CITY OF AUSTIN – DEVELOPMENT SERVICES DEPARTMENT
SITE PLAN APPLICATION – MASTER COMMENT REPORT

CASE NUMBER: SP-2018-0595C
REVISION #: 00
CASE MANAGER: Randall Rouda
UPDATE: U0
PHONE #: 512-974-3338

PROJECT NAME: 1303, 1311 & 1401 South Lamar
LOCATION: 1311 South Lamar Blvd

SUBMITTAL DATE: January 9, 2019
REPORT DUE DATE: February 7, 2019
FINAL REPORT DATE: February 14, 2019
7 DAYS HAVE BEEN ADDED TO THE UPDATE DEADLINE

| SHEET 1 OF 1 | OVERHEAD_WORKING_CLEARANCES | |

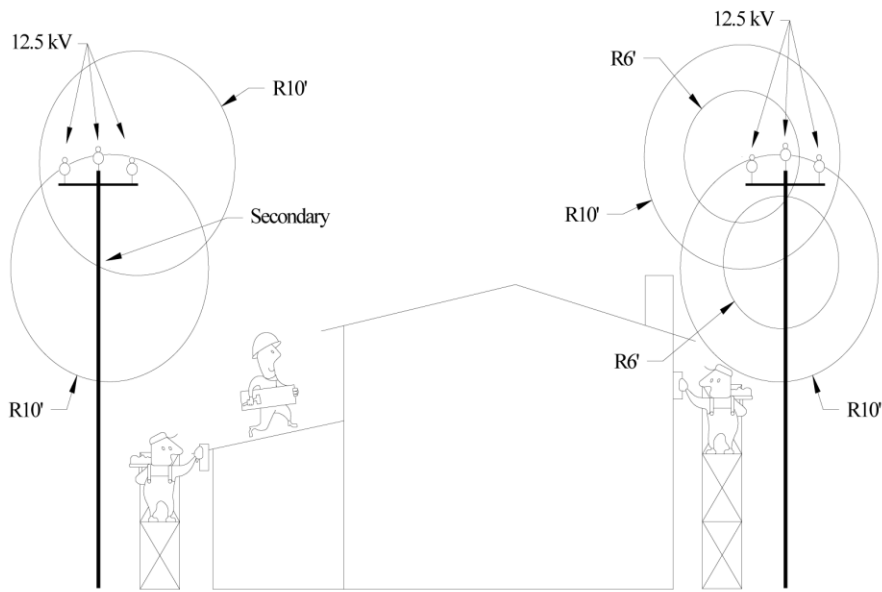
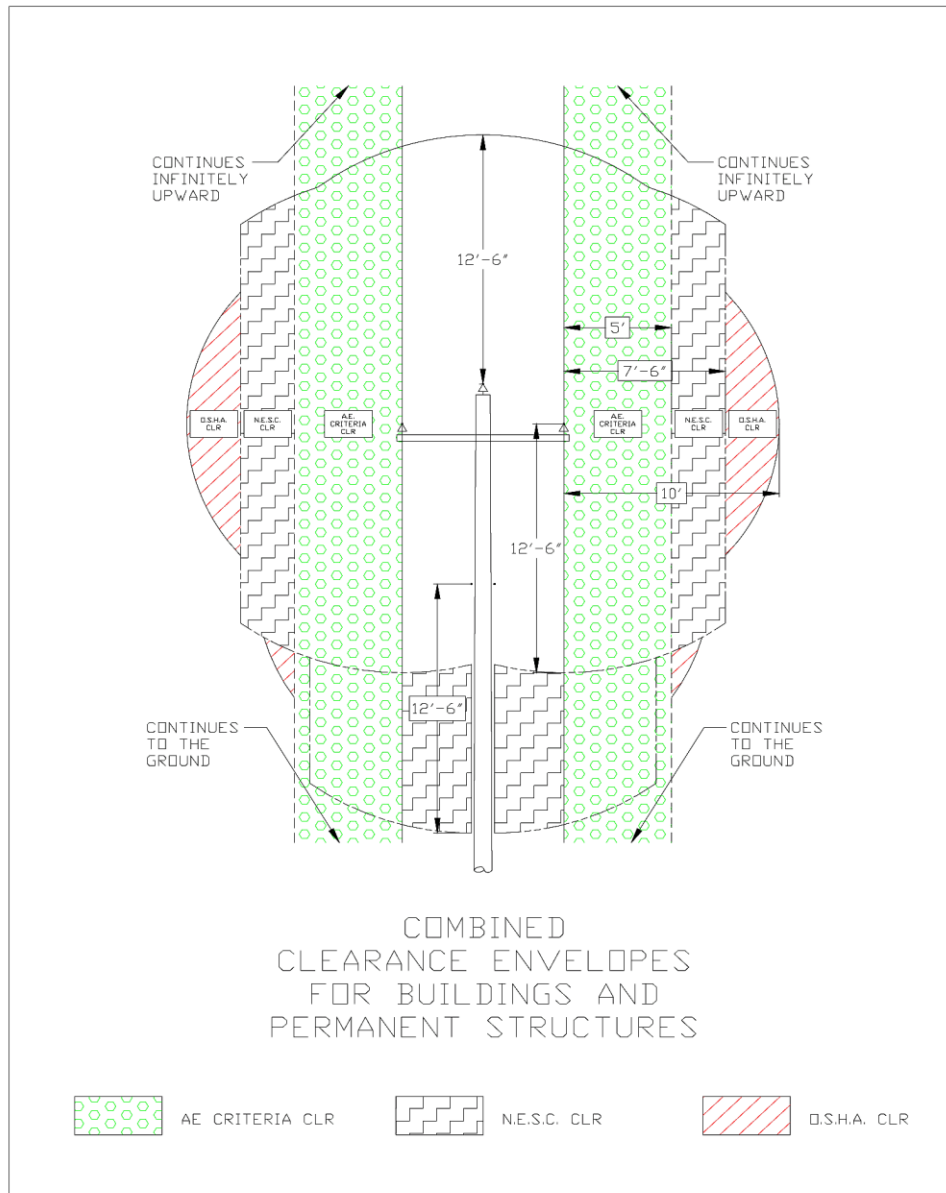
EL 1. The existing overhead facility on the north lot line must be cleared of the proposed building shown. This facility has 4 ft. cross arms from the center of the pole. The following must be shown and building relocated for safety and clearance per AE, NESC and OSHA requirements.

A profile plan of each side of the proposed building including overhangs and balconies and the existing electrical pole include the height with all three conductors/neutral. Link of the criteria manual

NOTE:
 The workers, scaffolding, and anything in the workers hands must stay out of the appropriate working clearance circles (10' radial clearance form any energized wire).
